**GEOTECHNICAL UPDATE AND RESPONSE TO
CITY OF SAN DIEGO DEVELOPMENT SERVICES DEPARTMENT
(DSD - GEOLOGY) PROJECT ISSUES DATED DECEMBER 16, 2022
PROPOSED RESIDENTIAL DEVELOPMENT ("COVE HOUSE")
LOTS 2 AND 17 OF BLOCK 46, LA JOLLA, SAN DIEGO COUNTY
CALIFORNIA 92037, ASSESSOR'S PARCEL NUMBERS
(APNS) 350-131-02-00 AND -29-00**

Subject: Geotechnical Update and Response to City of San Diego Development Services Department (DSD - Geology) Project Issues Dated December 16, 2022, Proposed Residential Development ("Cove House"), Lots 2 and 17 of Block 46, La Jolla, San Diego County, California 92037, Assessor's Parcel Numbers (APNs) 350-131-02-00 and -29-00

Figure 1

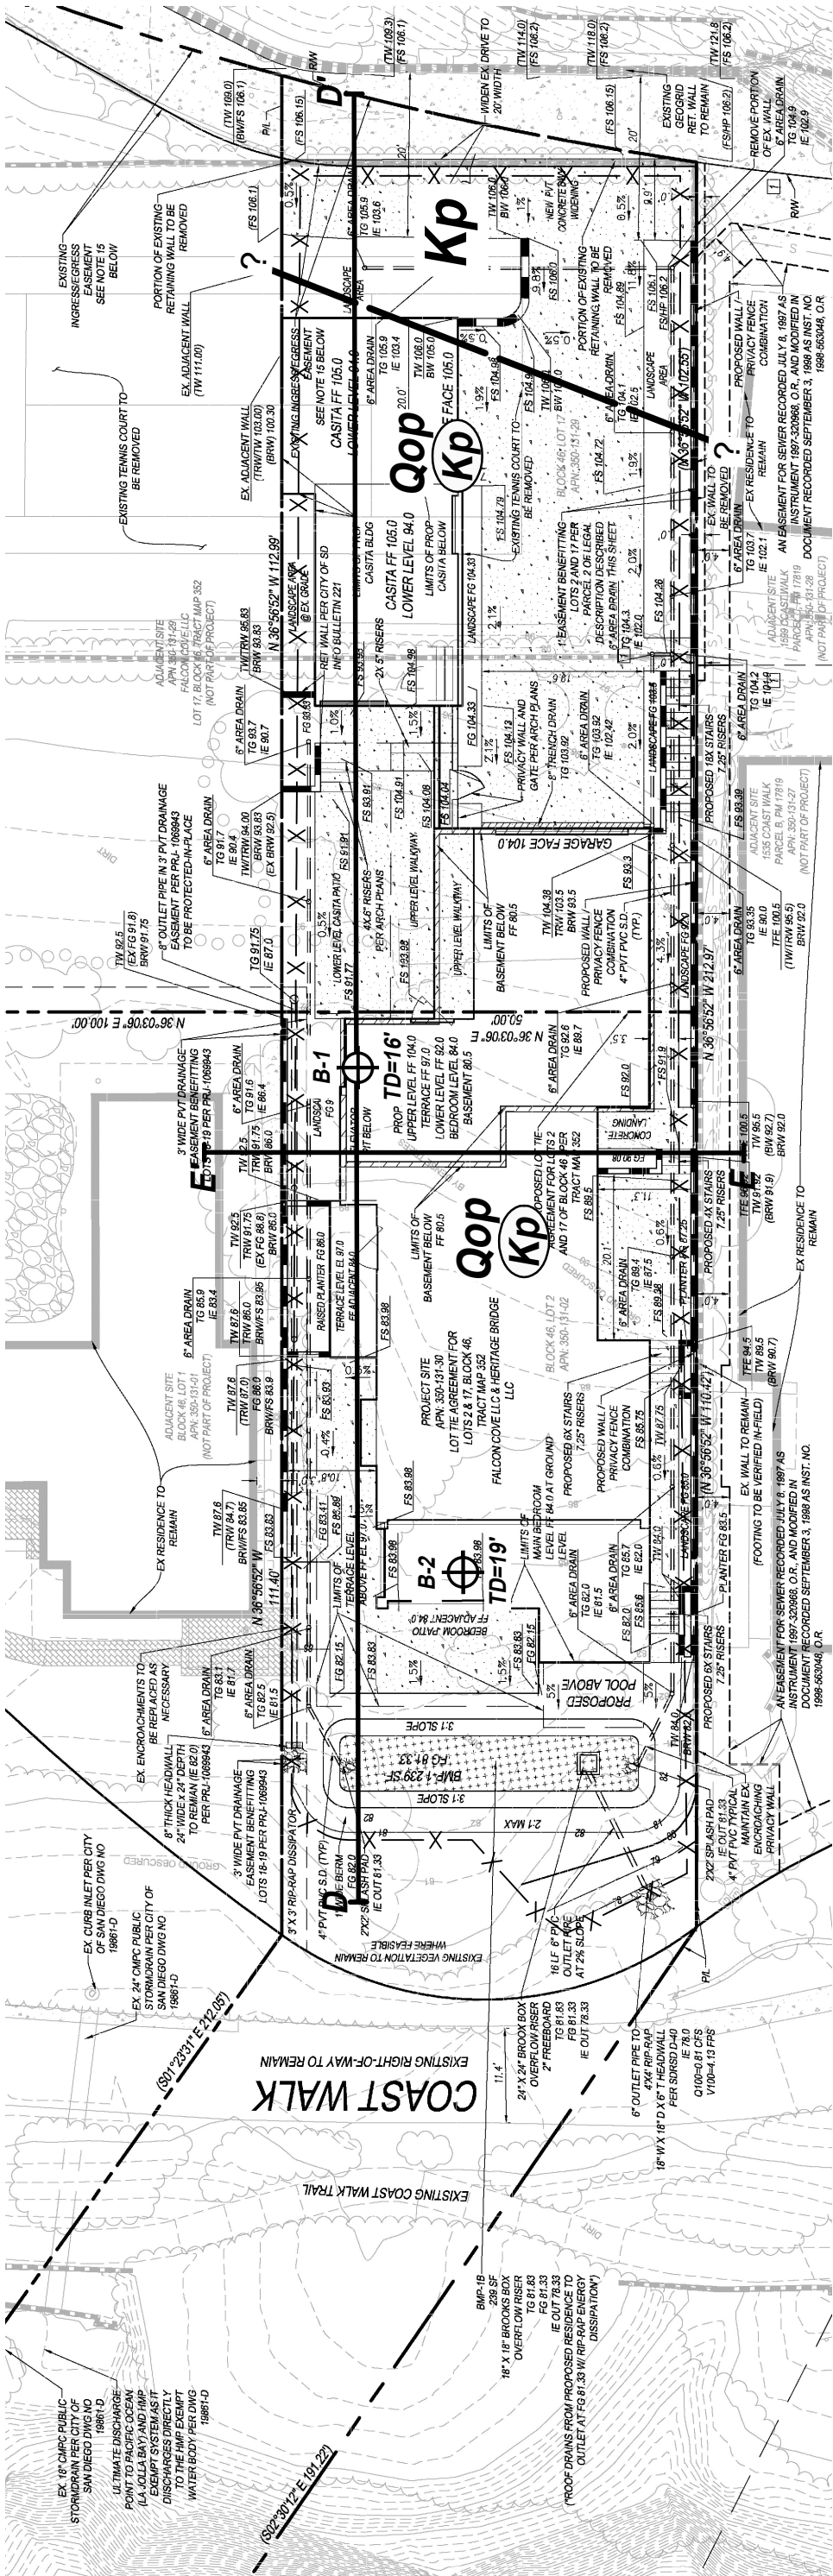
If remedial grading is recommended, show the limits of the recommended remedial grading on an updated geologic/geotechnical map and cross section. Note, the geotechnical consultant should determine if the limits of grading may impact environmental resources on the site.

See Figures 1 and 2. The determination of environmental resources is the responsibility of others and not GSI. Thus, the project consultant responsible for the identification of environmental resources should evaluate potential conflicts between such resources and the limits of grading, which could extend to the property boundaries using shoring or slot grading / slot excavation.
